AEP-NRC-2008-52  
10 CFR Part 50.46

Subject: Donald C. Cook Nuclear Plant Unit 1  
Response to Request for Additional Information, Second Round, Regarding  
Re-analysis of Small-Break Loss-of-Coolant Accident (TAC No. MD5297)

SBLOCA Reanalysis – Response to the Second Round NRC Requests for Additional  
Information Question 1 (Non-proprietary)

Figure 1

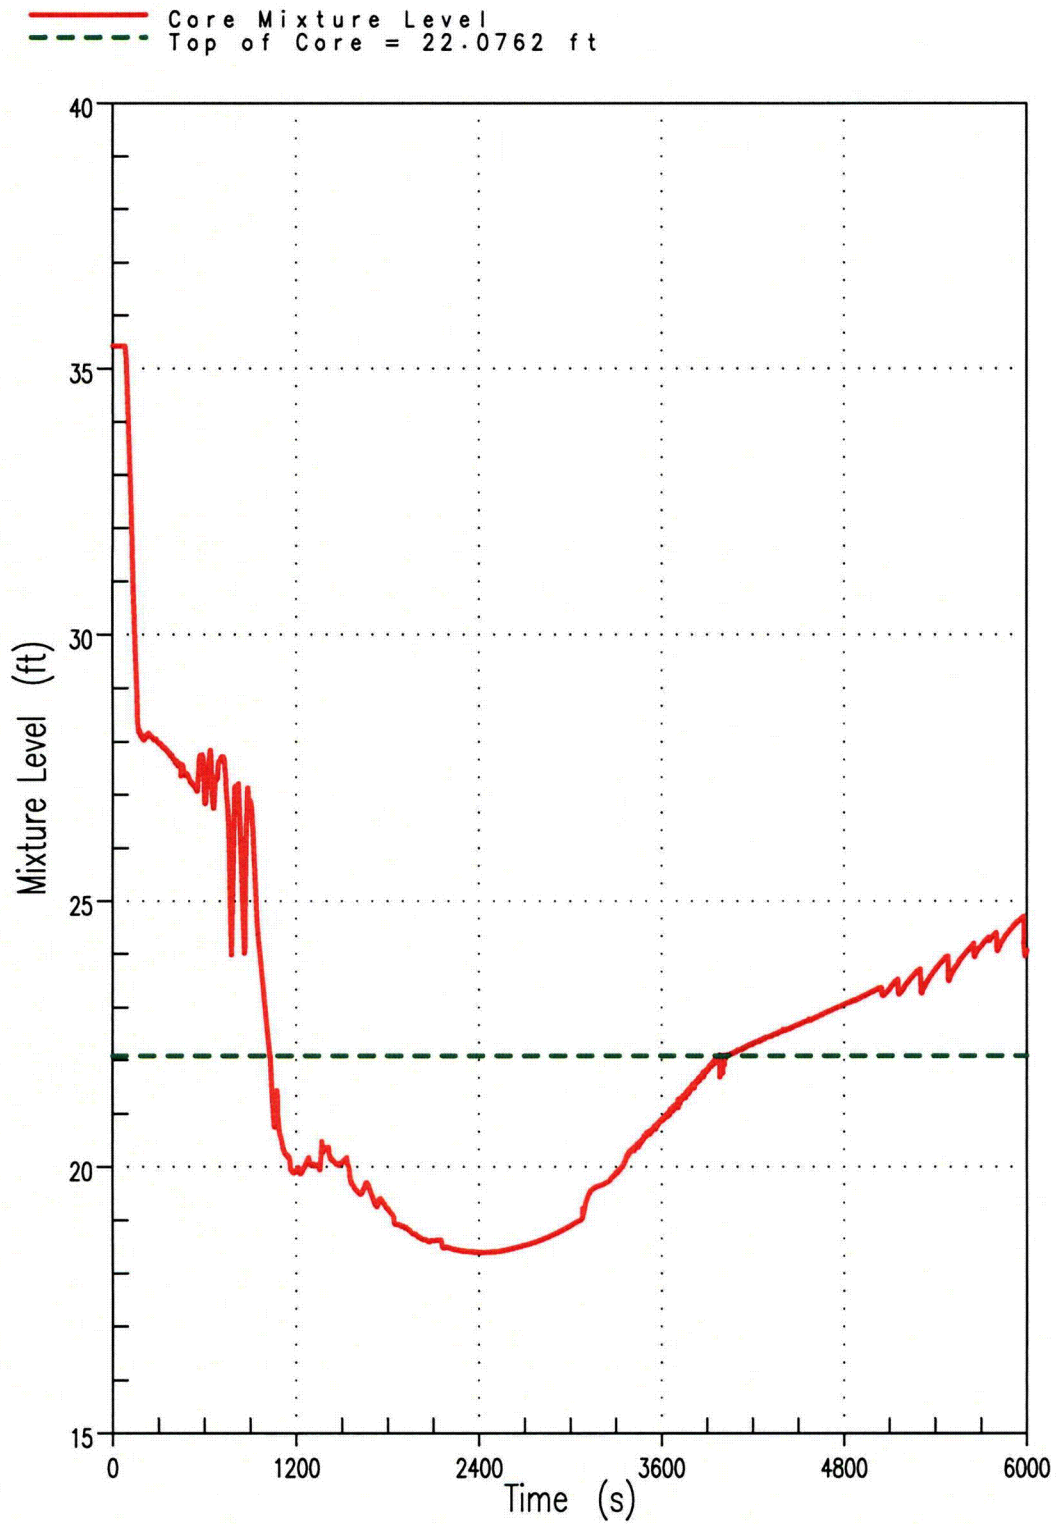
*Please provide an explanation, with appropriate supporting information, to understand the non-physical core mixture level behavior exhibited by the two-phase mixture level plots for the evaluated break spectrum contained in the small-break loss-of-coolant accident evaluation model re-analysis applicable to the Donald C. Cook Nuclear Plant, Unit 1.*

Similar two-phase core mixture level behavior is observed for the 2, 2.5, 2.75, 3, 3.25 and 3.5-inch break cases of the Cook Nuclear Plant (CNP) Unit 1 Small Break Loss-of-Coolant Accident (SBLOCA) analysis. The following response utilizes the 2.5-inch break case to explain the behavior. Figure 1 provides the core mixture level response for the 2.5-inch break. At approximately 1200 seconds, it is observed that the mixture level begins to “hang” (i.e., the level stops decreasing) until approximately 1600 seconds. This behavior is attributed to the relaxation of a developed differential pressure between the upper plenum (UP) and the downcomer (DC) whose onset occurs after loop seal clearing.
